CHILDREN'S HOSPITAL
OF ORANGE COUNTY

TOWER II

EXTERIOR GRAPHICS

AGC20.0

GVD: Ground Vehicular Directional

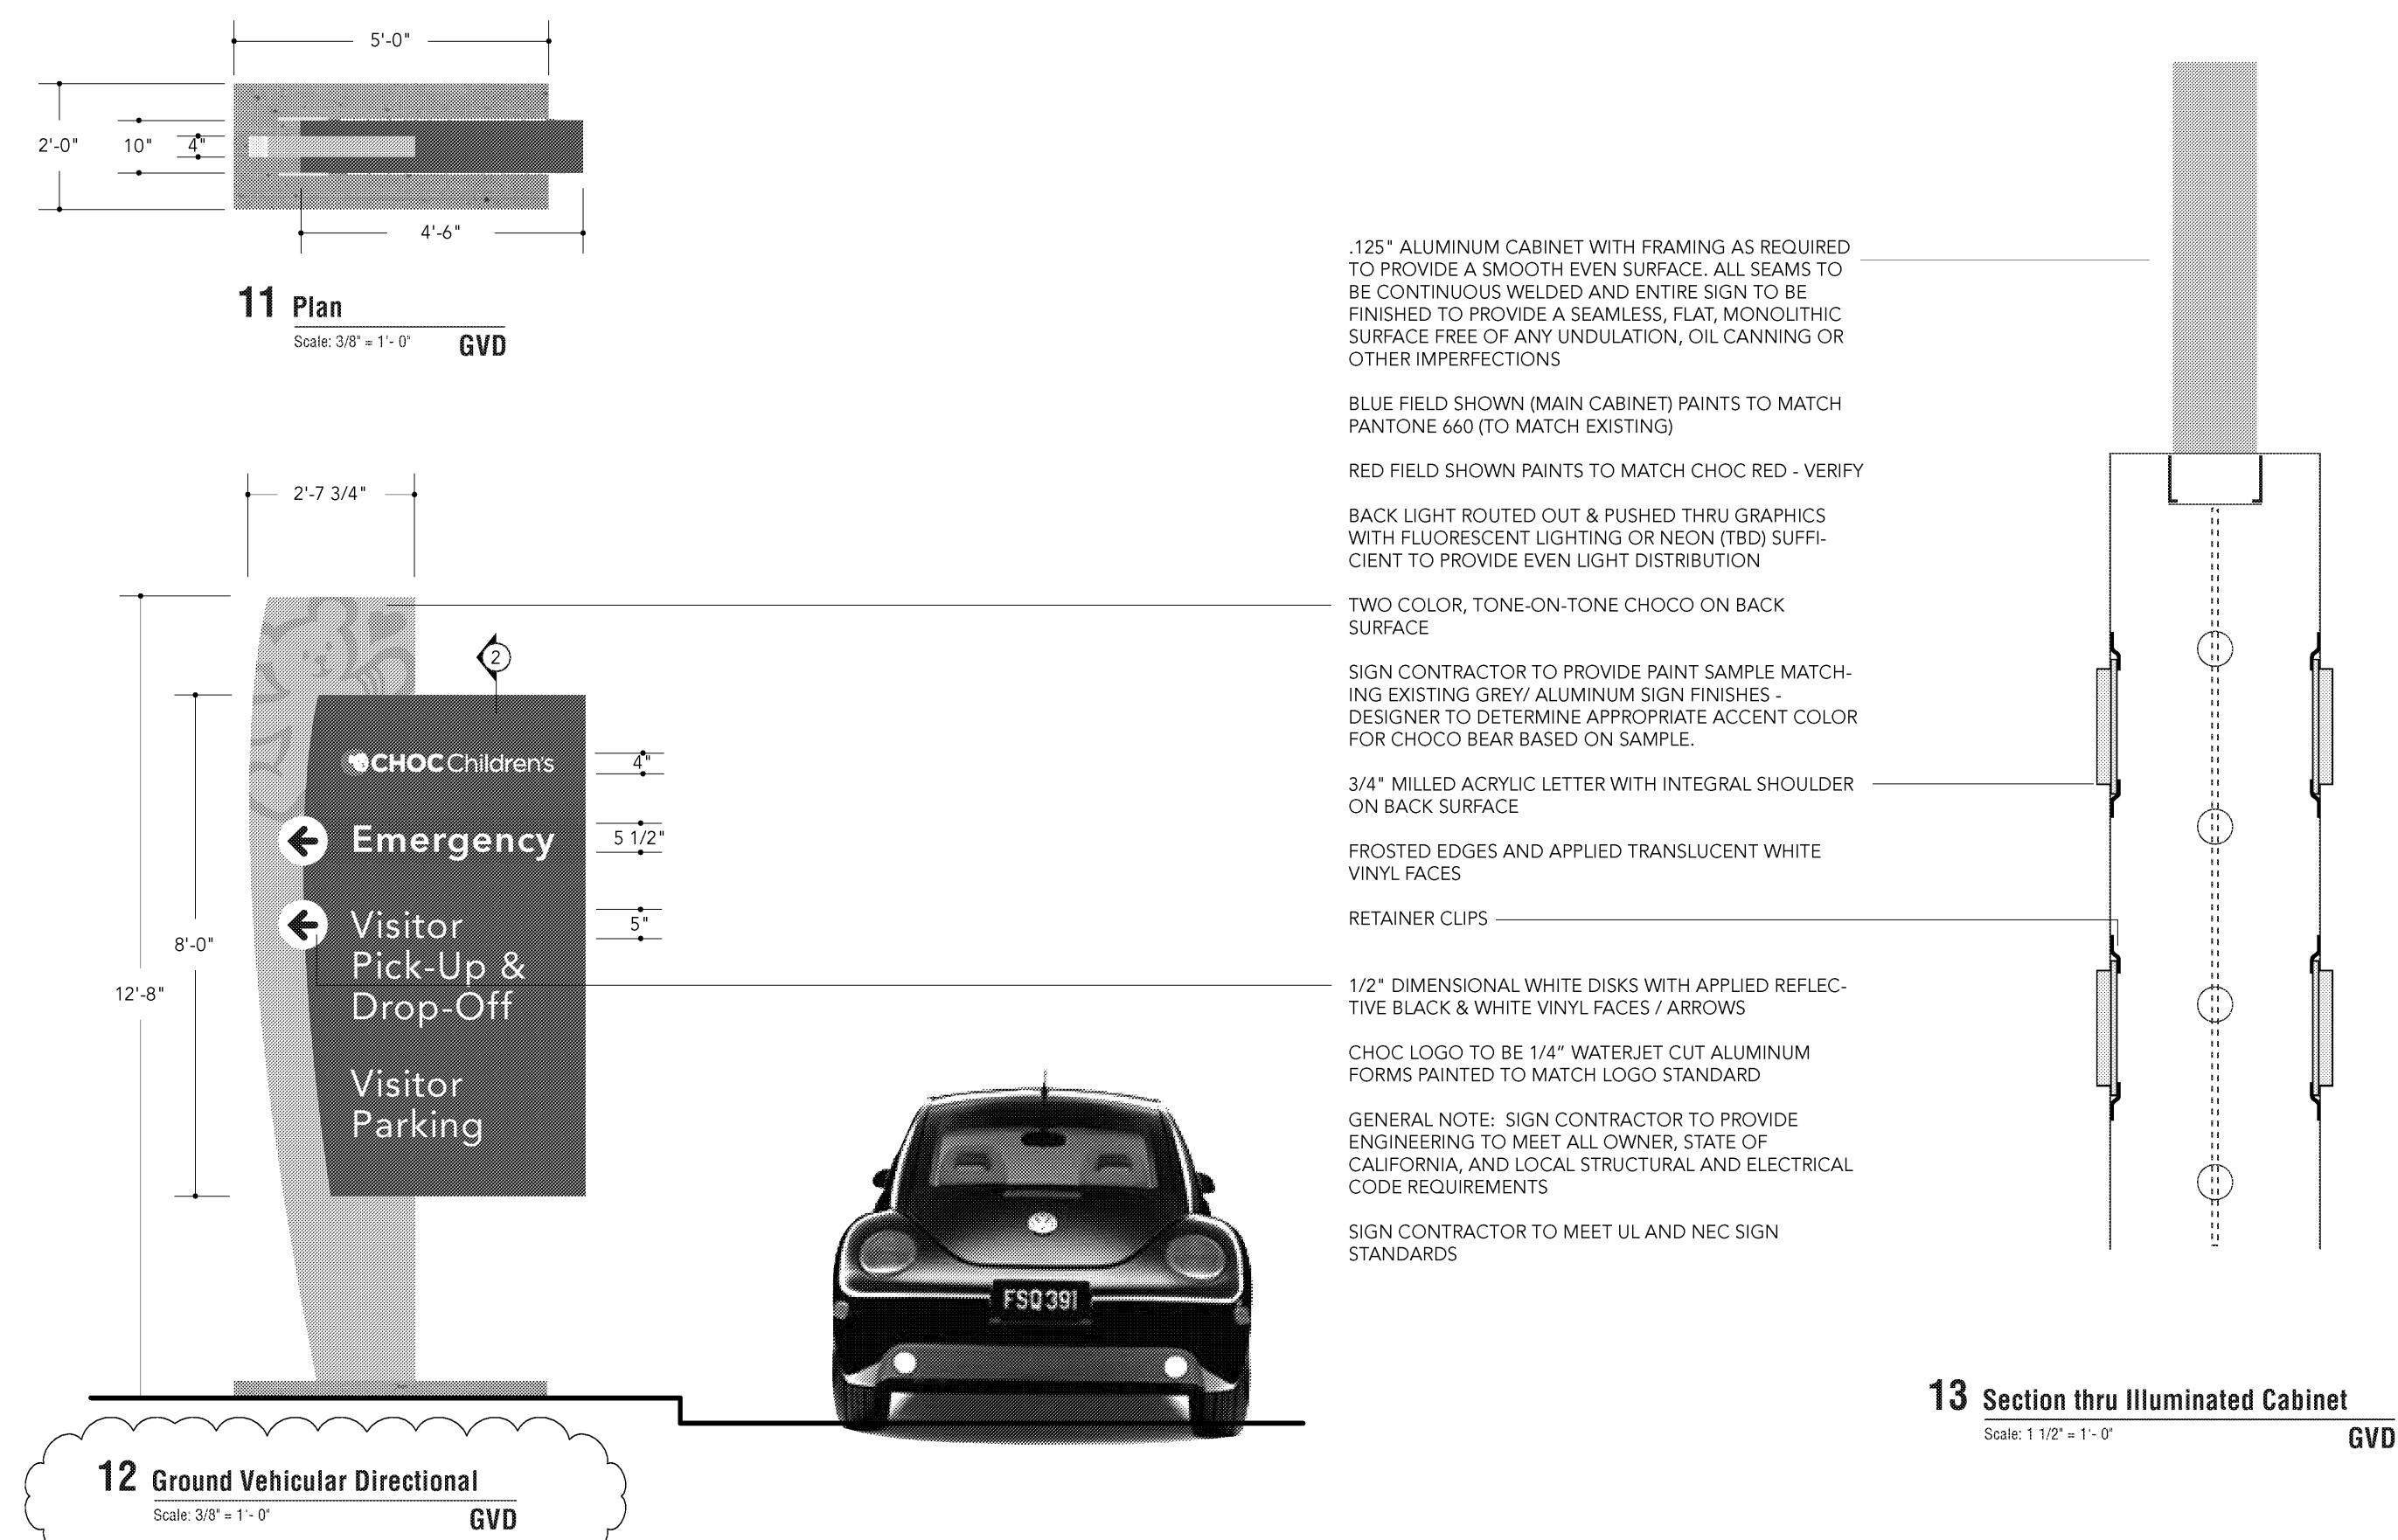
RFI 5356
